Planning Commission Staff Report

Project type: Site Development Section Plan
Meeting Date: June 24, 2024
From: Shilpi Bharti, Planner *SB*
Location: 16839 N. Outer 40 Road
Description: Summit Topgolf, Lot C1: A Site Development Section Plan, Landscape Plan, Lighting Plan and Architectural Elevations for a retail building located on a 2.16-acre tract of land located north side of north outer 40 road, zoned "PC"-Planned Commercial.

Bethlehem Shared Services, LLC on behalf of Cigars International, has submitted a Site Development Section Plan, Landscape Plan, Lighting Plan, and Architectural Elevations for a proposed retail/bar building located at 16839 N. Outer 40 Road in Summit Topgolf subdivision.

Figure 3: Front Elevation

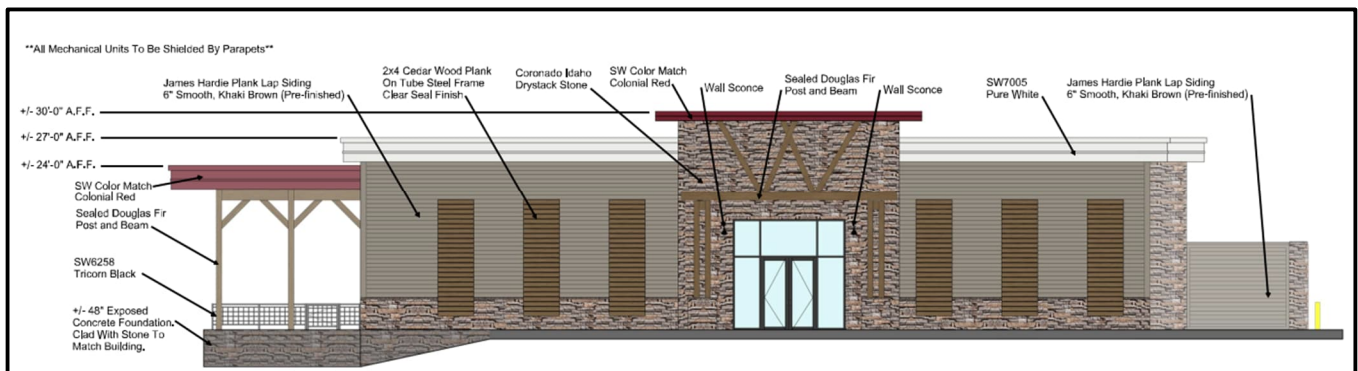
1. Provide additional landscaping in front of the building, around the patio area and at the trash enclosure walls. The parking lot islands would be easier to maintain if planted with shrubs and perennials rather than sod.
2. Add stone veneer to the exposed patio foundation area.

The Applicant has addressed the above comments.

Figure 5: Lighting Plan

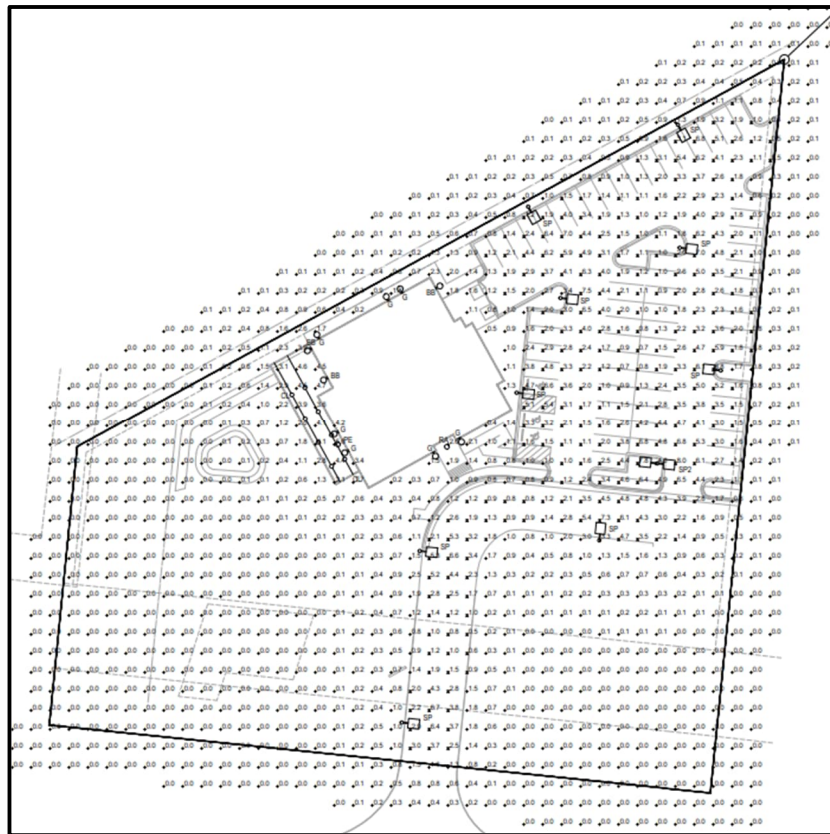
There are six different types of light fixtures proposed for this development which includes wall pack light, catenary light, wall sconce, pendant, recessed downlight, and site poles. The wall sconce, pendant

and catenary light does not comply with Unified Development Code light fixture i.e. fully shield flat lens, hence require Planning Commission approval. The wall sconce and pendant are proposed near the entries, and catenary light is proposed for the patio. These fixtures may be approved by the Planning Commission.
